ADDENDUM NO. 2

RE: Carthage Water System Improvements
Contract 2 – Raw Water and Interconnection Pump Stations
Town of Carthage
LKC No. Cart-23.01

Nicks Creek Pump Station
Modification Plans

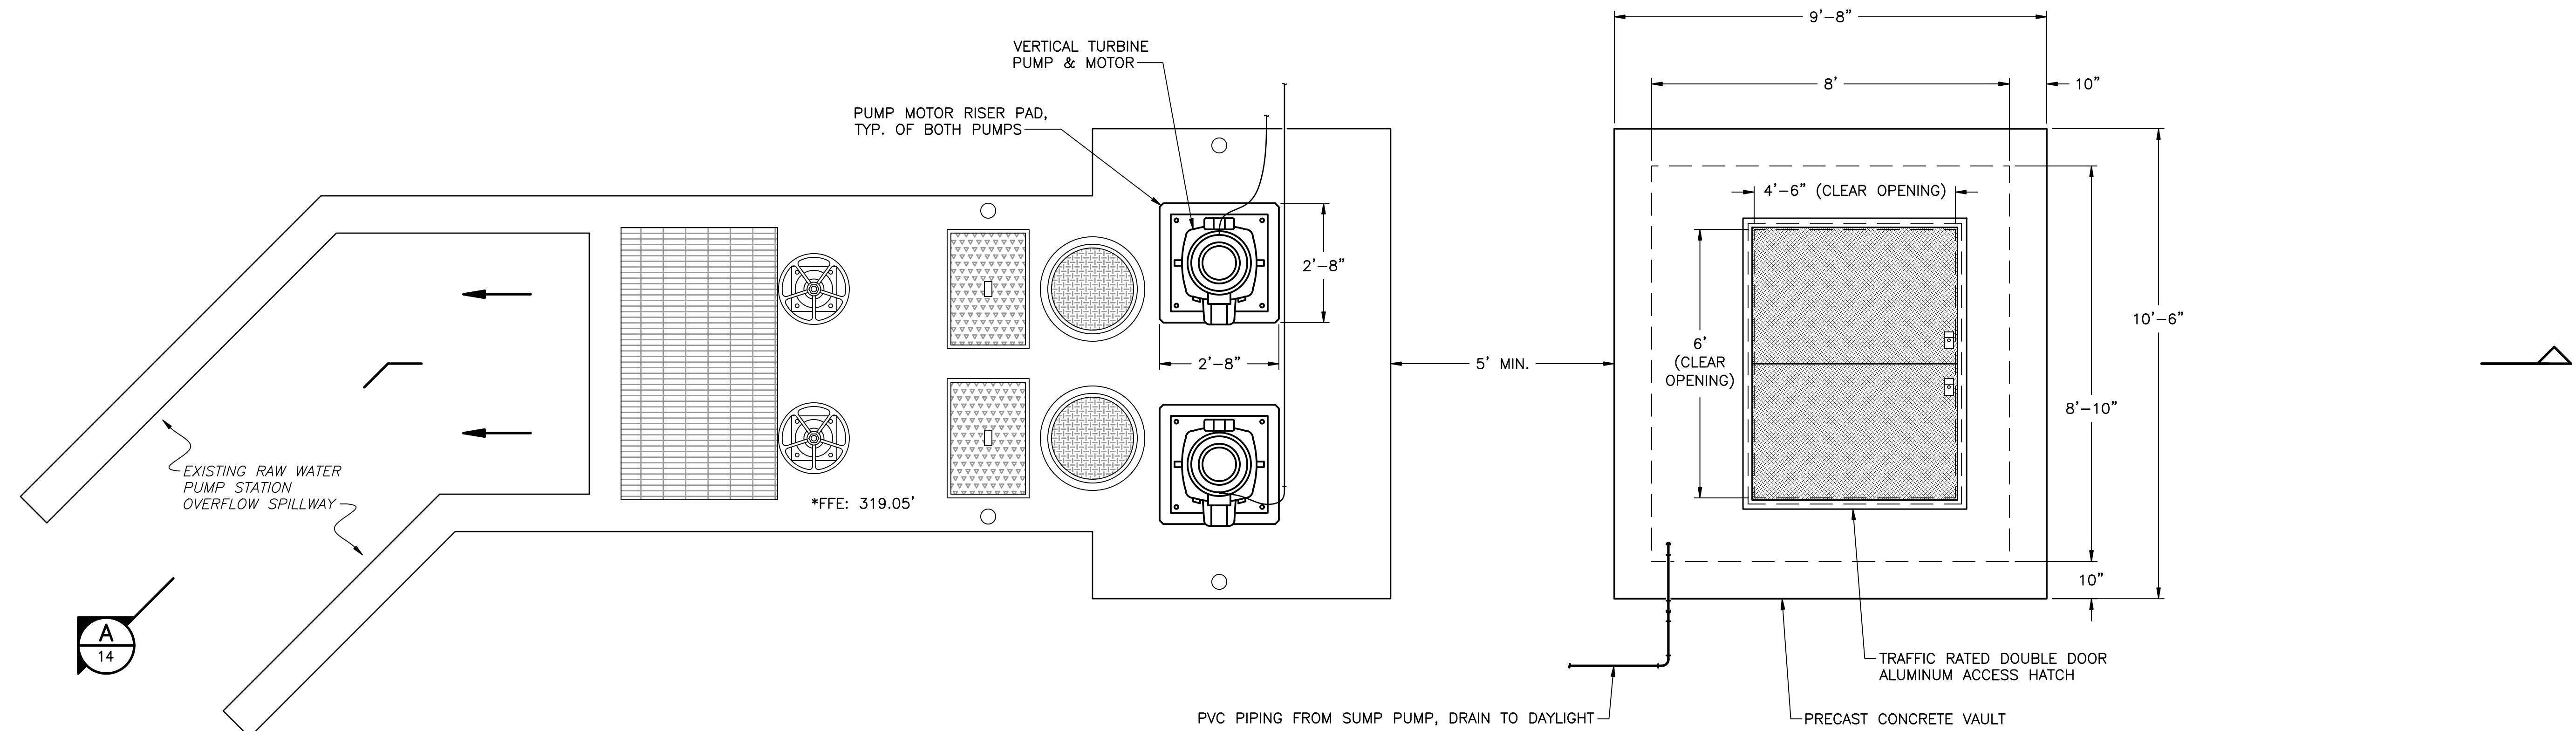
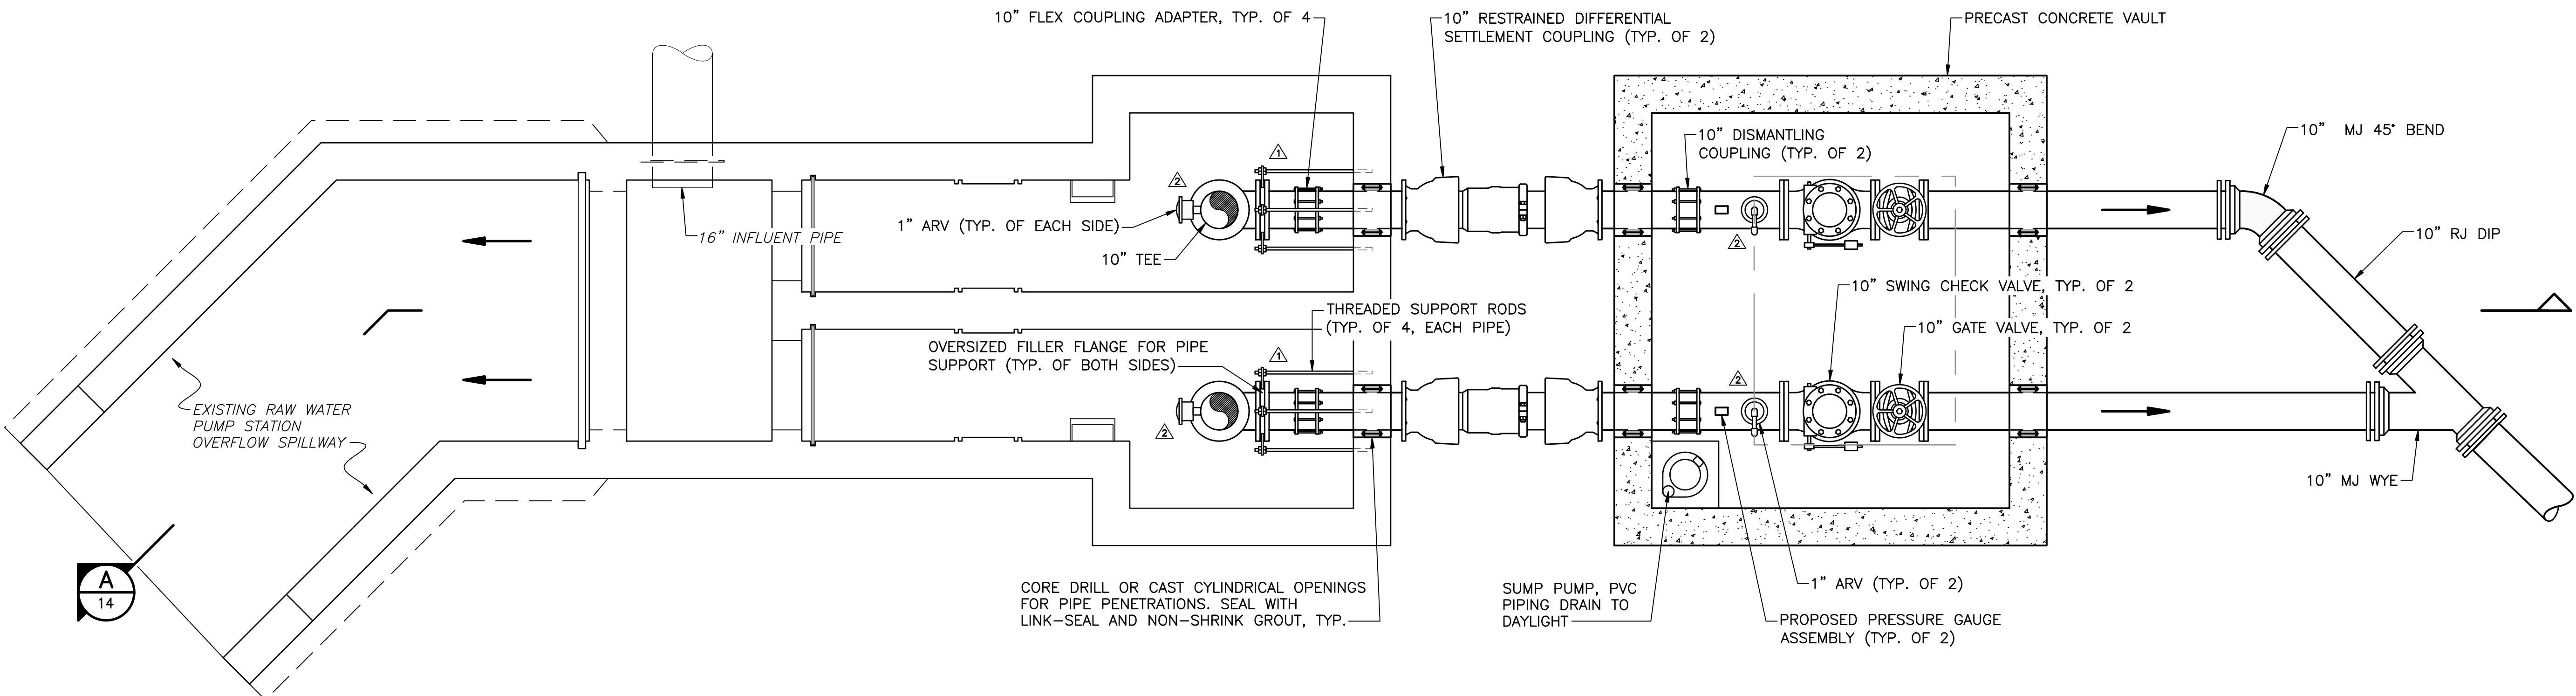
1. **Plan Modifications:** Plan sheets 13 and 14 have been revised to add ARV's to column and discharge piping and modify the way the pumps are restrained. Pricing should be based on the attached revised sheets.
2. **Electrical modifications:** Electrical requirements for several aspects of the project are to be modified as Indicated below.

REVISIONS			
SYM.	DESCRIPTION	DATE	BY
1	TENSION ROD SUPPORTS AND OVERSIZED FLANGE ADDITIONS	07-11-2025	DJN
2	ADDED 1" ARV'S (4) TOTAL	07-11-2025	DJN
